# UNITED STATES PATENT AND TRADEMARK OFFICE

APPLICATION NO.	FILING DATE	FIRST NAMED INVENTOR	ATTORNEY DOCKET NO.	CONFIRMATION NO.
09/681,441	04/05/2001	Peter Fall	VCC0031-US	4762

# Office Action Summary

EXHIBIT 11

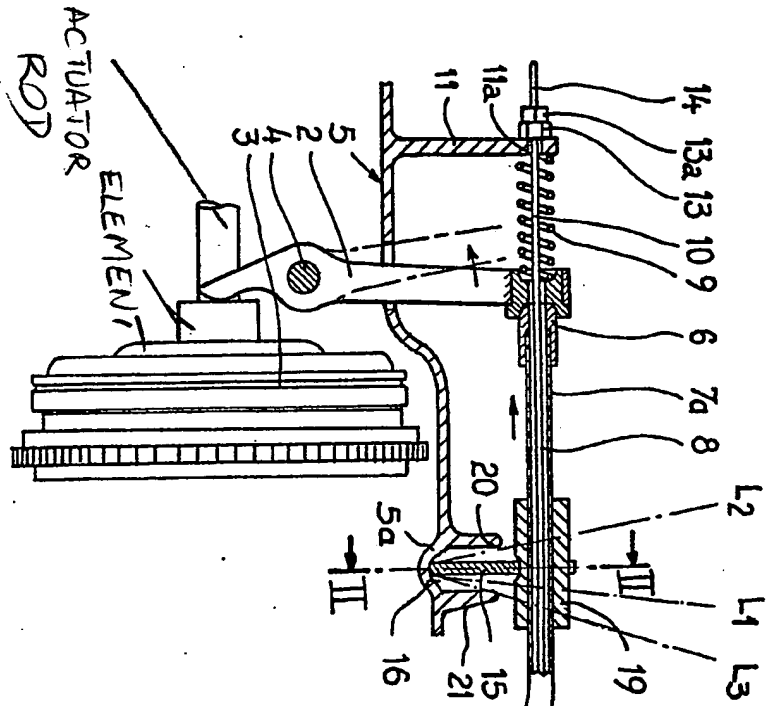
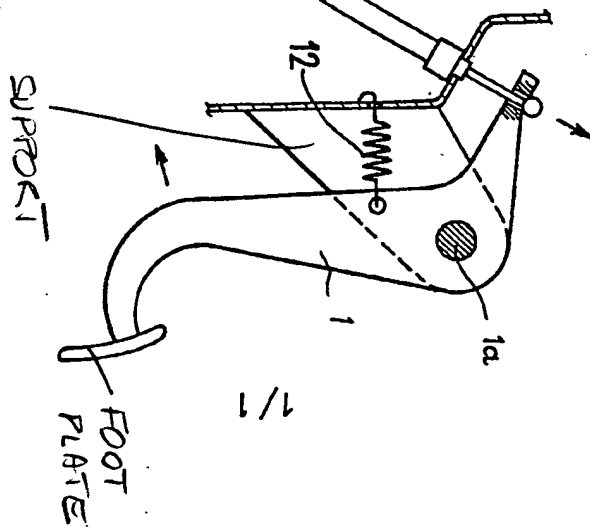
- a support (i.e., a bracket unnumbered at 12 in Fig. 2, see Exhibit attached) fixed in the cab;

- motion-transmitting element 7 that is joined firstly to the portion of the pedal arm 1 on the other side of the pivot axis 1a from the foot plate and secondly to a pivotally mounted lever 2 that is configured so that pivotation thereof actuates an operating device 3 fixed to an element (Exhibit) spaced from the support;

Regarding claim 6, the lever 2 is joined to a rocker arm 15, 19, which, when the lever 2 is pivoted, acts on an actuator rod (see Exhibit) for a brake servo unit 3, which is located on the outside of an intermediate wall 5 on the inside of which the support is located spaced from the intermediate wall 5.
